**ISSUE:** Certificate of Appropriateness for alterations

**APPLICANT:** Waterford Place Homeowners Association

**LOCATION:** Old and Historic Alexandria District  
150 Waterford Place

**STAFF RECOMMENDATION**

11/9/19

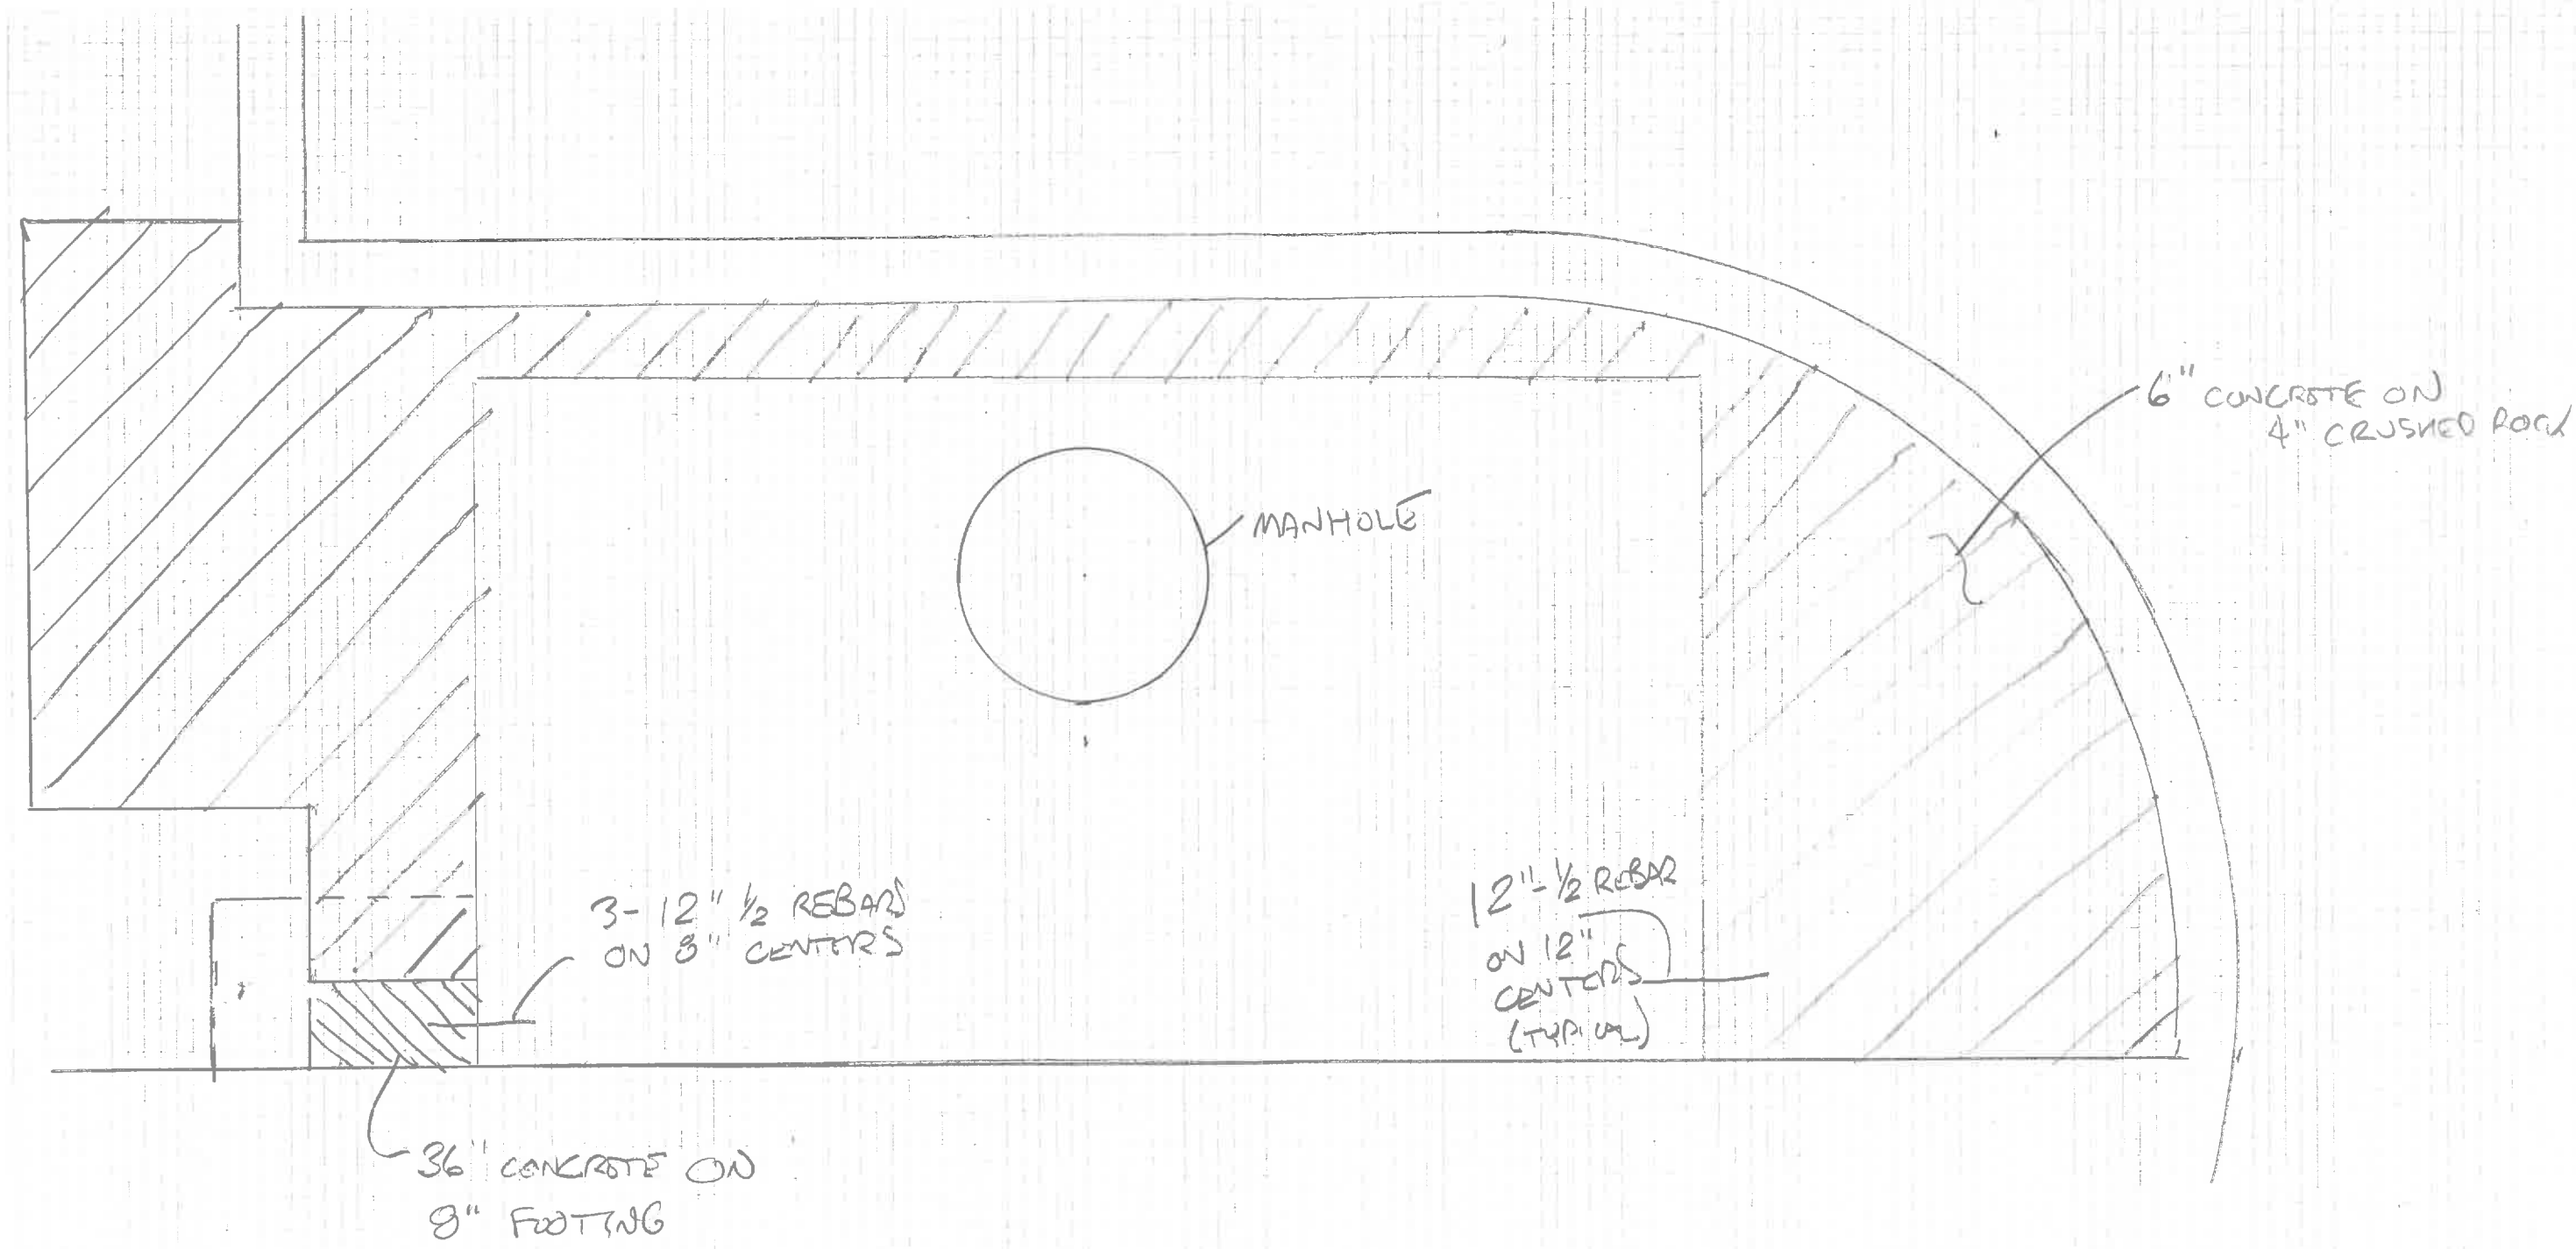
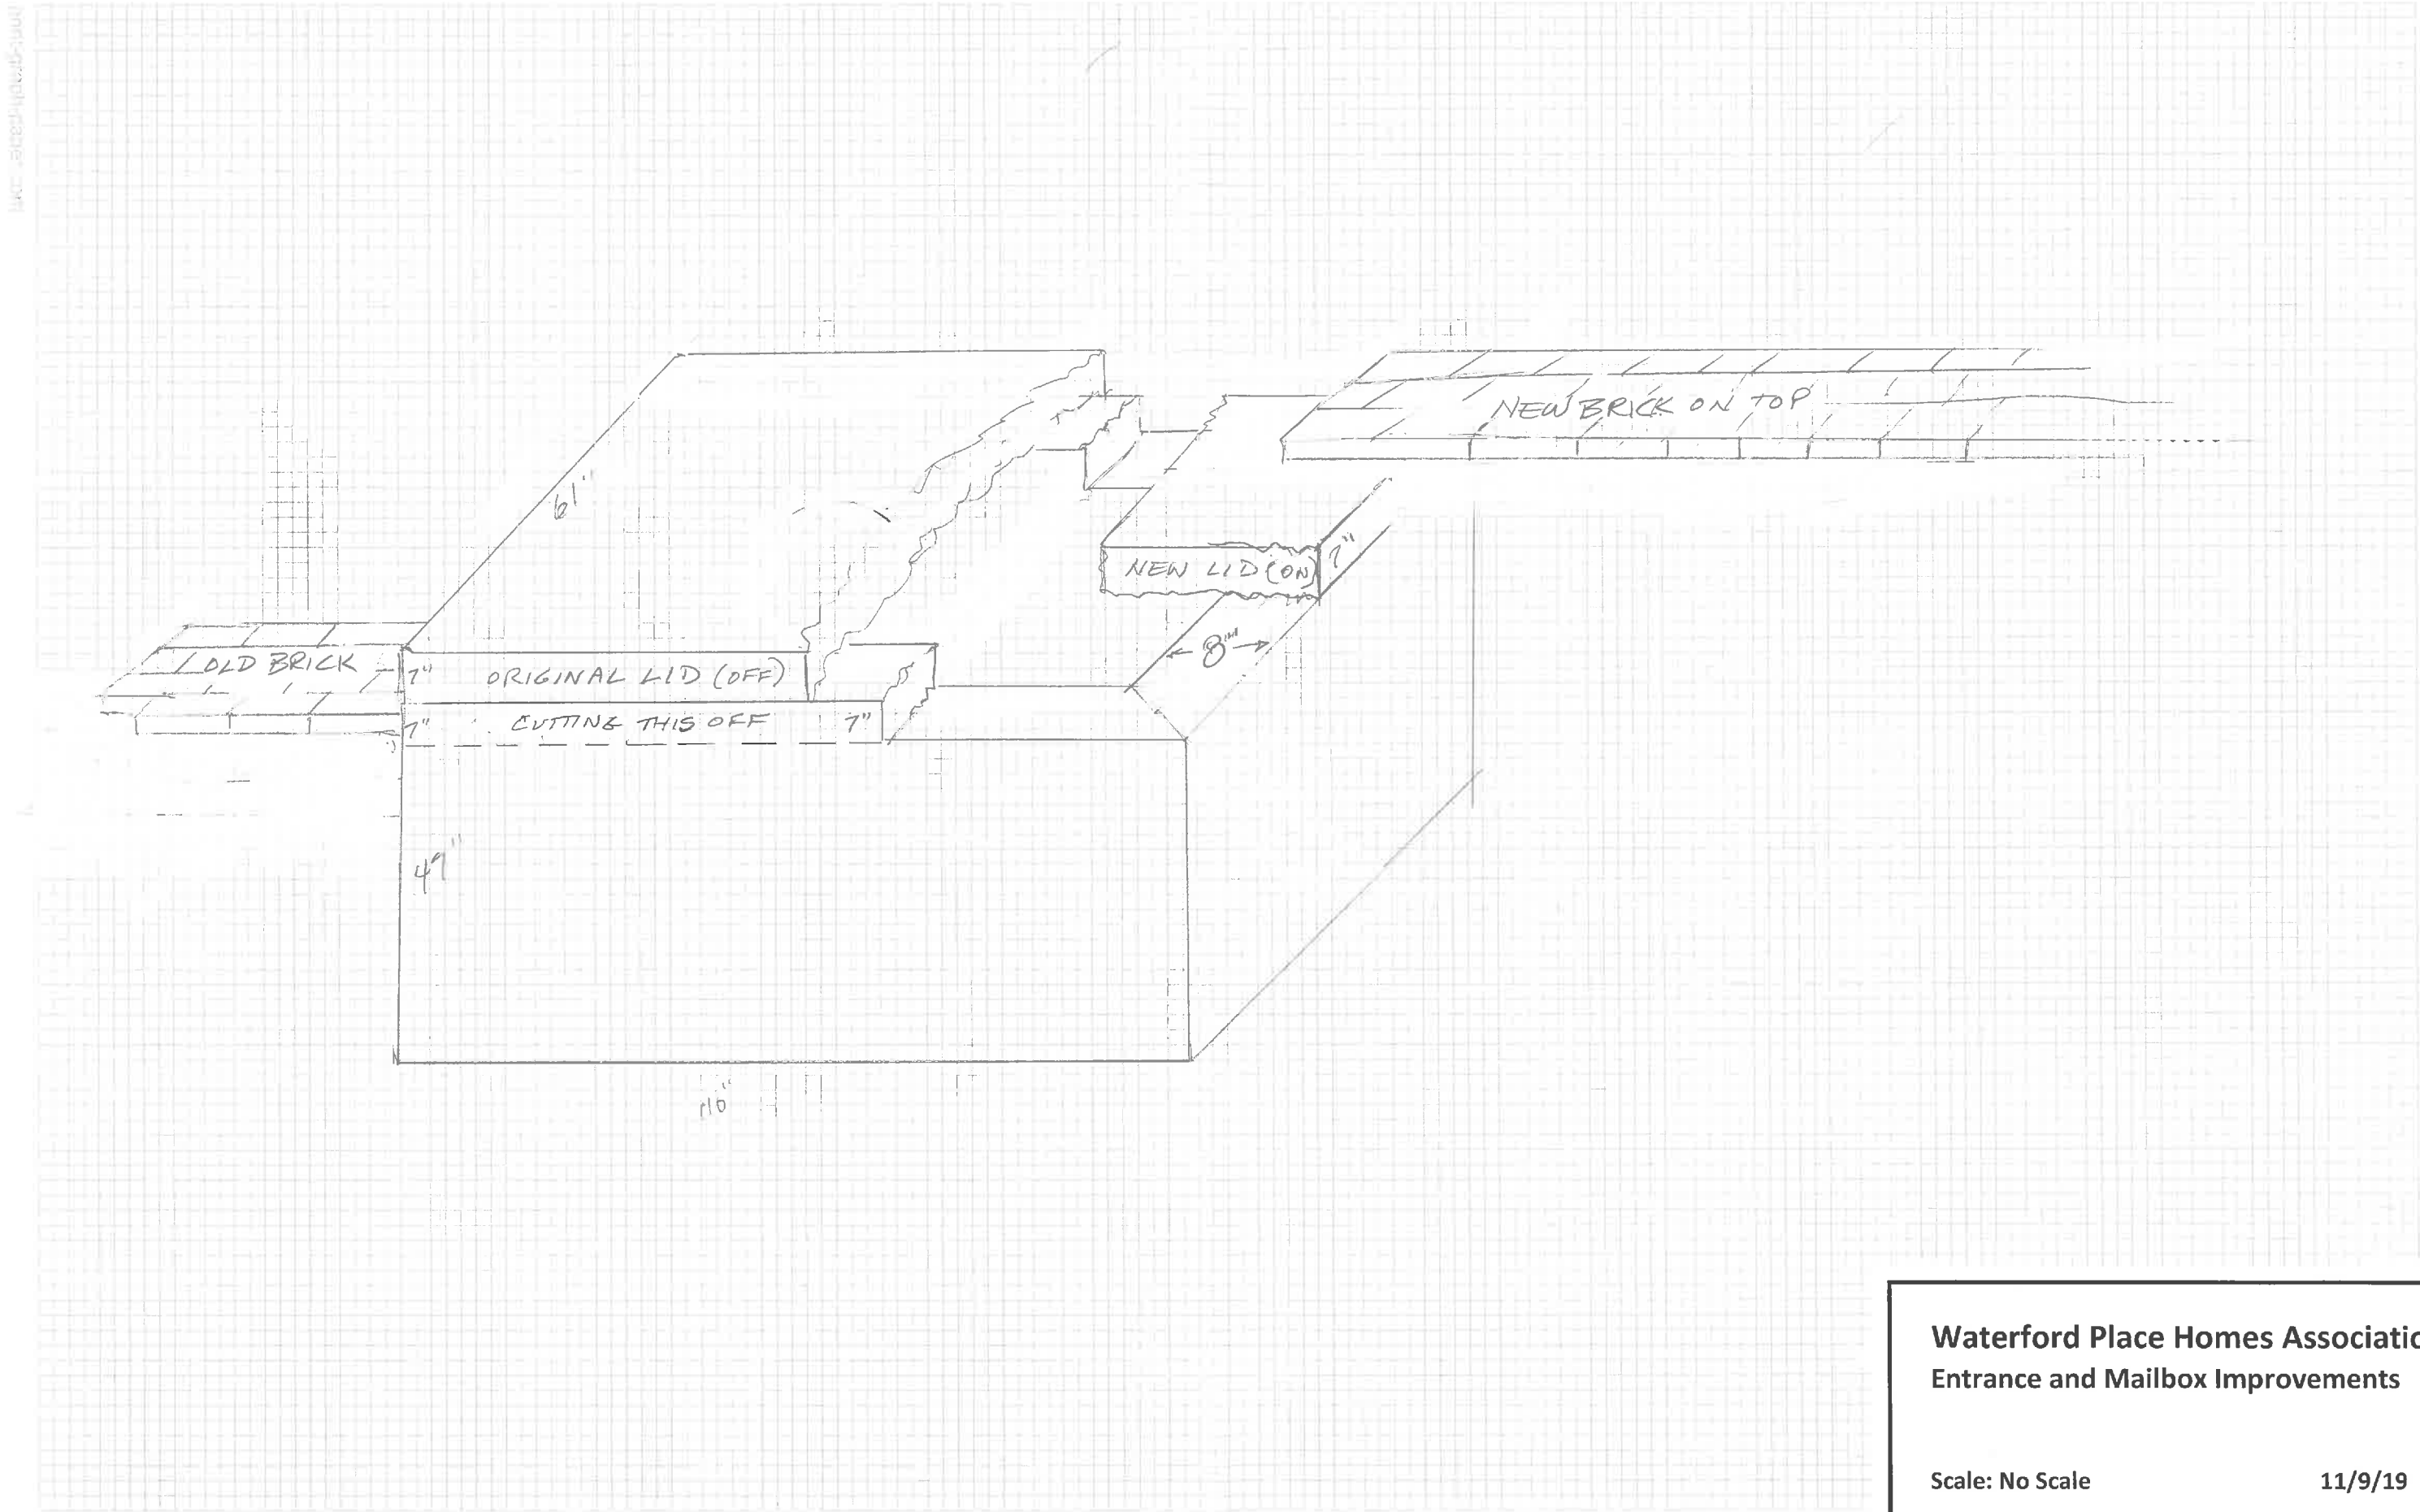
Even though the proposed wall is not considered a garden wall but a screening landscape feature that will block the new mailbox structures and parking from public view, the *Design Guidelines* states that “Masonry fences and walls of brick or stone are generally appropriate throughout the historic districts.” Moreover, there are several brick walls screening parking lots of townhouse

complexes within the Old and Historic Alexandria District. Currently, the unattractive existing mailbox structure faces South Union Street (Figure 2). Staff finds the proposed planter/wall to be appropriate and an enhancement to the Waterford Place complex.

- C-1 Please provide wall heights and location of proposed light fixtures.

**A** LIGHT POST DETAIL  
SCALE: N.T.S.

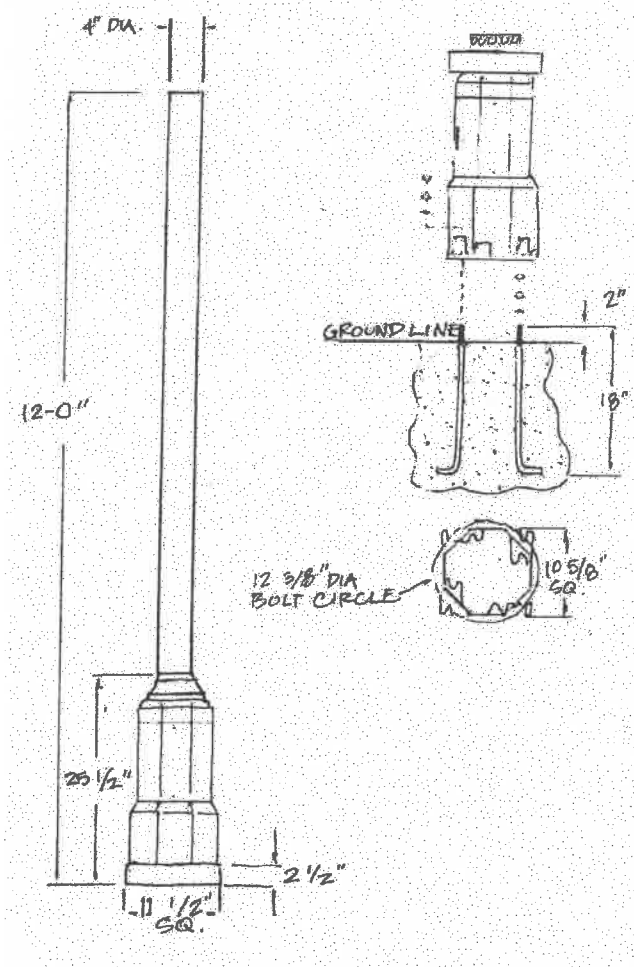
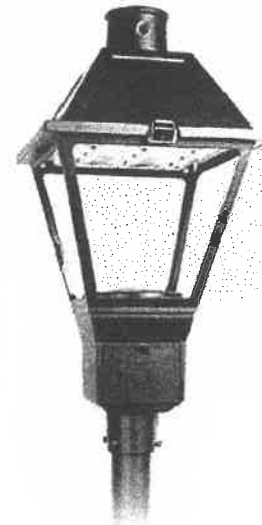
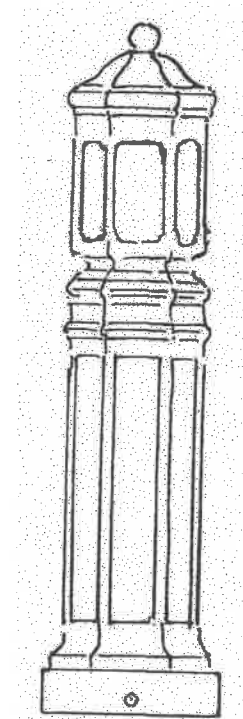
The *Guidelines* state that “Lighting fixtures should be sympathetic to the style of the building and not detract from the architectural character of the building.” Staff has no objection to the installation of lighting poles since they are appropriate in scale and design to the townhouses within the complex and practically not visible from the public right-of-way.

WALPOLE LATTICE PANELS

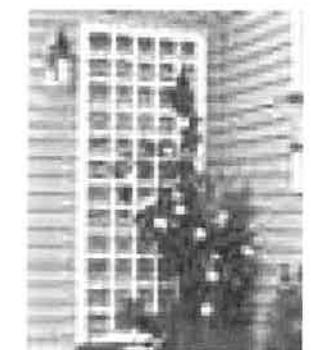
The BAR considers landscape lattices to be accessory structures which require BAR approval. The *Guidelines* state that “Exterior finishes for accessory structures should be selected to complement the main building. For example, accessory structures constructed of wood should be painted to match the color of the main structure.” Therefore, staff recommends the landscape lattices be painted to match the brick wall on which they are mounted.

Staff recommends approval of the Certificate of Appropriateness for alterations with the condition that the landscape lattices be painted to match the brick wall they are mounted on.
